Table 2.3.4-1 Combination of Sources and Receptors for Steam System Piping Failure Analysis (Sheet 1 of 12)

US-APWR Design Control Document

Figure 2.3-2 Site Plan with Release and Intake Locations

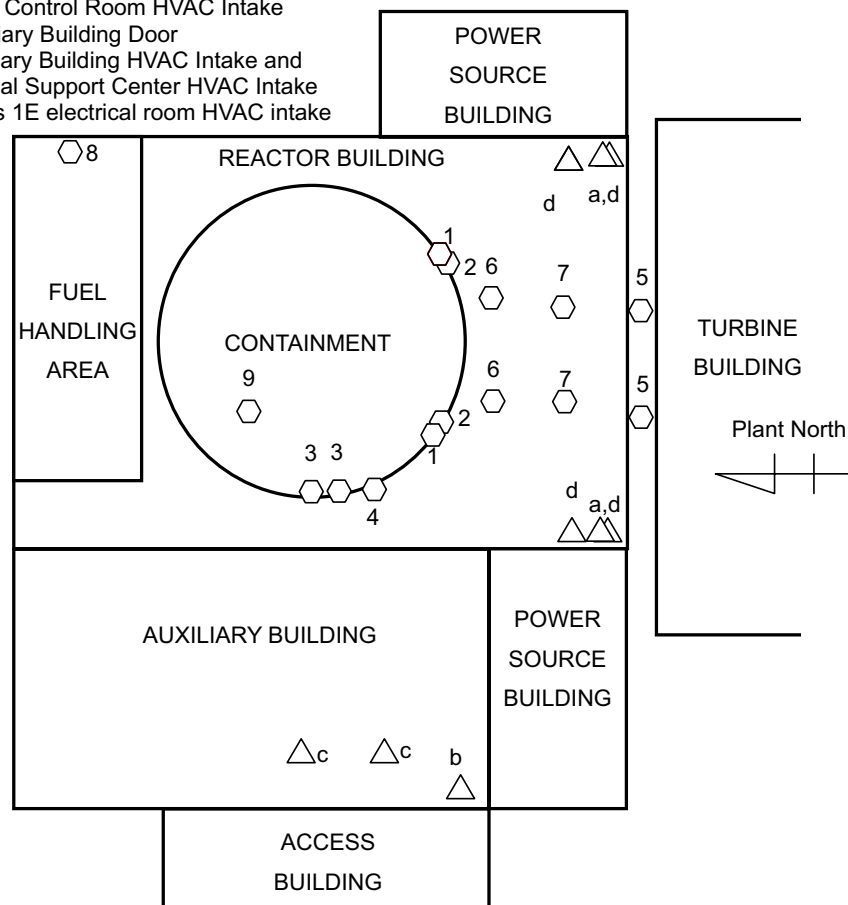
1. Containment Shell to Class 1E electrical room HVAC intake (As Diffuse Area Source)
2. Containment Shell to Main Control Room HVAC Intake and Class 1E electrical room HVAC Intake (As Diffuse Area Source)
3. Containment Shell to Auxiliary Building HVAC Intake and Technical Support Center HVAC intake (As Diffuse Area Source)
4. Containment Shell to Auxiliary Building Door (As Diffuse Area Source)
5. Main Steam Line (Source points are in the west and the east.)
6. Main Steam Relief Valve (Source points are in the west and the east.)
7. Main Steam Safety Valve (Source points are in the west and the east.)
8. Fuel Handling Area
9. Plant Vent

- a. Main Control Room HVAC Intake
- b. Auxiliary Building Door
- c. Auxiliary Building HVAC Intake and Technical Support Center HVAC Intake
- d. Class 1E electrical room HVAC intake
